Scott Horsley
Water Resources Consultant
65 Little Road • Cotuit, MA 02635 • 508-364-7818

May 16, 2024

RE: Thorndike Place

I have reviewed the recent update report prepared by BSC, dated April 24, 2024 and offer the following comments. We continue to disagree with the suggested use of 4.0 feet as an appropriate seasonal high groundwater level and believe that the on-site measurements provided by BSC need to be supplemented with a comparison with USGS index wells as recommended in the MADEP Stormwater Handbook.

Figure 2 – USGS Index Well Lexington (2009 – Present)

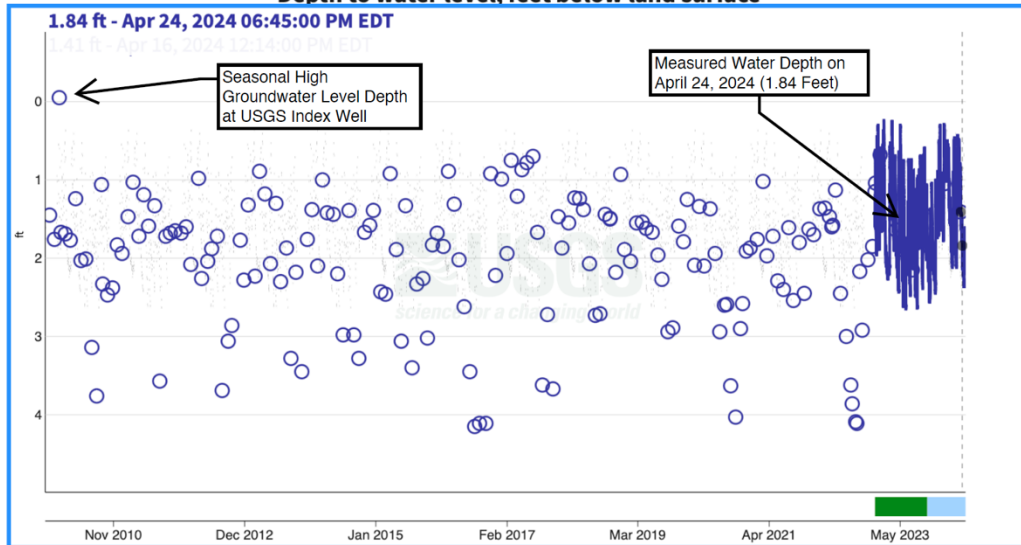
In accordance with the MADEP Stormwater Handbook we have compared this groundwater level measurement with the USGS Lexington well (see figure 2)¹. The records for this USGS well indicate that the water level on April 24, 2024 was 1.84 lower than the highest recording in 2009.

Figure 3 – USGS Lexington Well March – May 2024

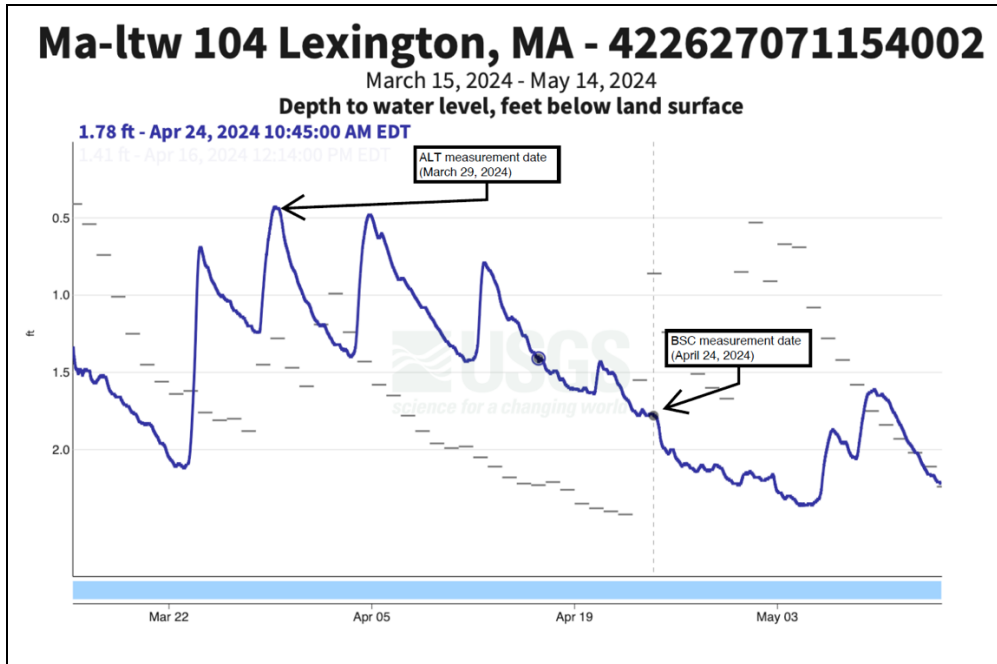
The shorter-term water level records at the USGS Lexington well provide a comparison between the BSC measurement on April 24, 2024 that indicates that it is approximately 1.4 feet lower than measurements just a month earlier in March 2024 (see figure 3). This comparison shows that groundwater levels peaked in late March and early April but then declined by 1.4 feet to April 24 (the date that BSC did the measurement).

Figure 4 – Groundwater Levels at Arlington Land Trust Wells at Dorothy Road

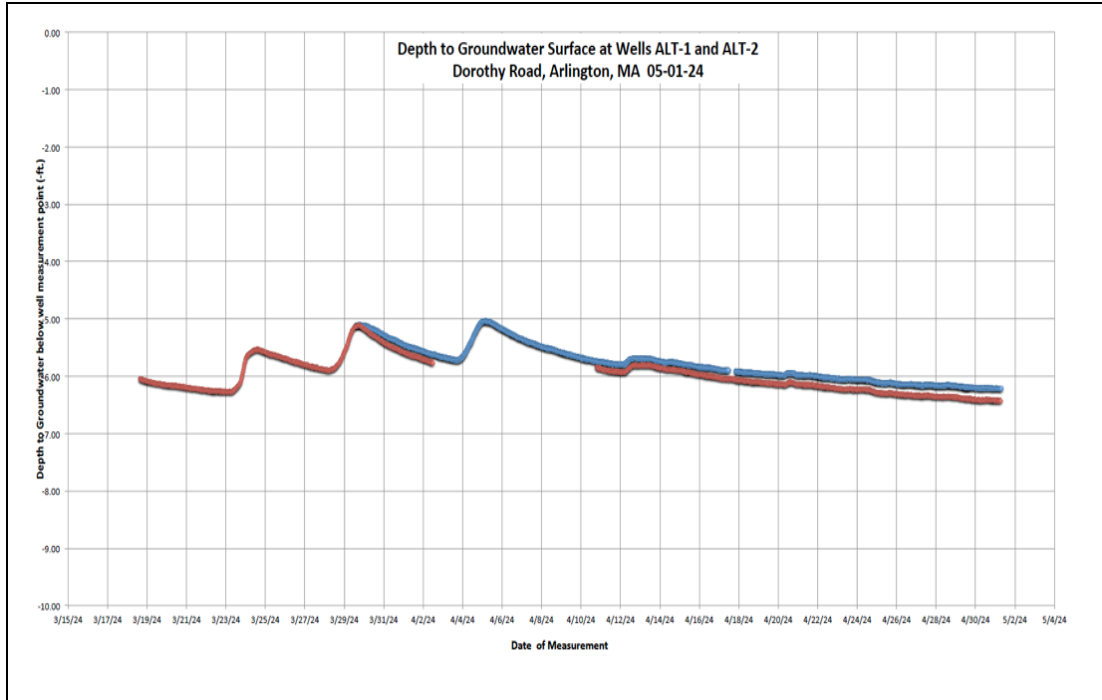
This same decline in groundwater levels is further corroborated with our own water level measurements at the Arlington Land Trust well located on Dorothy Road which showed a peak elevation on March 29, 2024 and a similar decline throughout much of April to a level of approximately 1.2 feet lower on April 24 (see figure 4)². This suggests that the relative groundwater level fluctuations over this period are consistent with the USGS Lexington well (which showed a 1.4-foot decline during this same period).
